# Warner's Pond Task Force Meeting | July 18, 2024

THE TOWN OF  
**CONCORD**  
MASSACHUSETTS

**EA Engineering,  
Science, and  
Technology, Inc., PBC**

# INTRODUCTION

Source: "Warner's Pond as a side-channel pond to Nashoba Brook" presentation

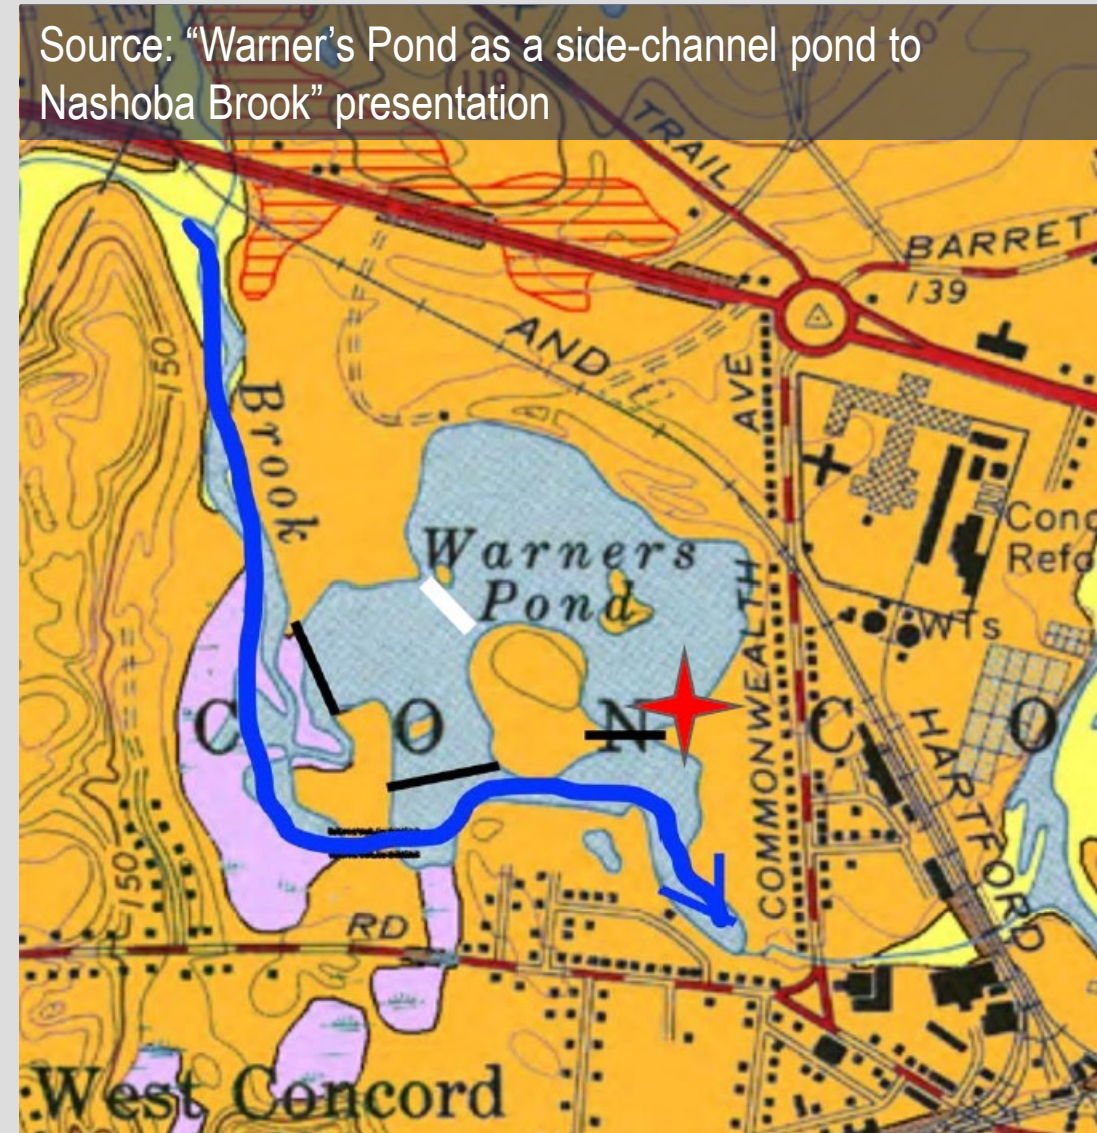
- Since the primary flow path of Nashoba Brook is through Warner's Pond, it is not clear that the brook would necessarily flow effectively along the desired pathway after berms are built. Excavation or dredging through uplands and wetlands southwest of the pond would likely be required to establish the new channel alignment and prevent ponding and erosion on the berms.

Proposal: Use the limited dredging option, but move the fill as shown by the white arrows to the positions of the solid white lines, which would separate the stream from the pond.

Alternative locations for fill islands are indicated by dashed white lines (in which case water flow would be in dashed blue.)
